V2 - CID-23-06

Town of Rolesville Planning  
Michael Elabarger

Re: CID-23-06 - Parker Ridge Preliminary Plat 1<sup>st</sup> Submittal – Planning/Zoning Comments  
Response to Comments

### CID 23-06, 1<sup>st</sup> Submittal - Engineering Response to Comments

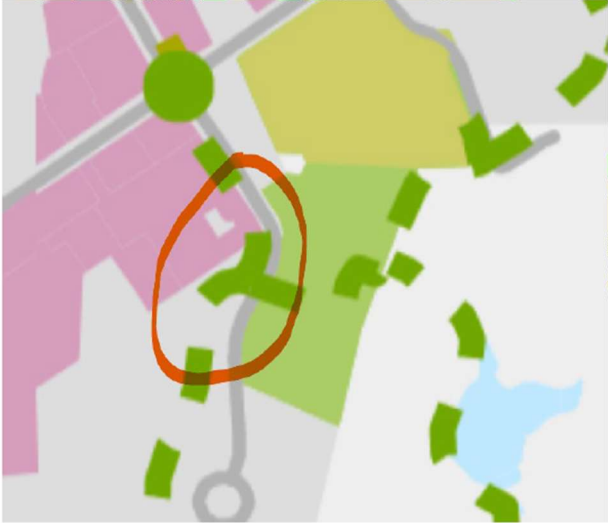
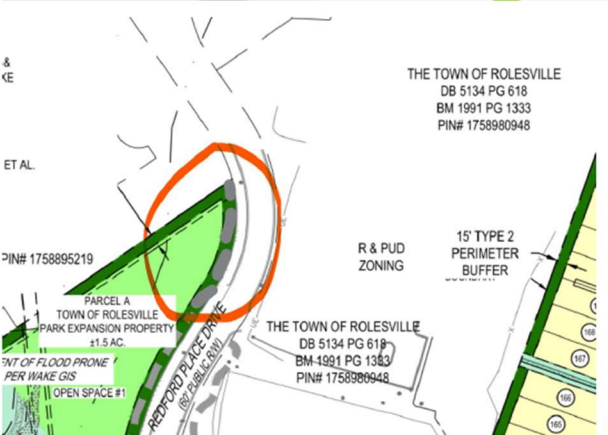
44. There is a symbol labeled on the markup that is typically used for light poles. Is that meant to be there?

**Response: No, this is a pipe linetype that is marking an existing storm pipe.**

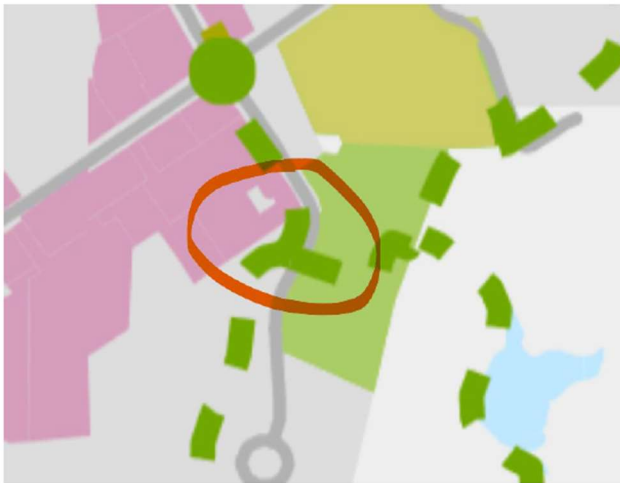
1. The Town would prefer the Greenway to be as close to the sidepath on Street H as possible. As shown currently on the concept plan, greenway users will have to cross the street twice to get onto the sidepath and ideally there is only one road crossing. Please revise the greenway that runs along the north side of the pond towards Long Melford Drive to align with the sidepath on Street H. It does look like there is a structure there (see Green highlighter circle below), is there any way to route the Greenway around this?

2.    **ow this.**  
sidepath continues north on this property continuing along Redford Place Drive

**Response: The greenway has been extended to end at the end of the town park property.**
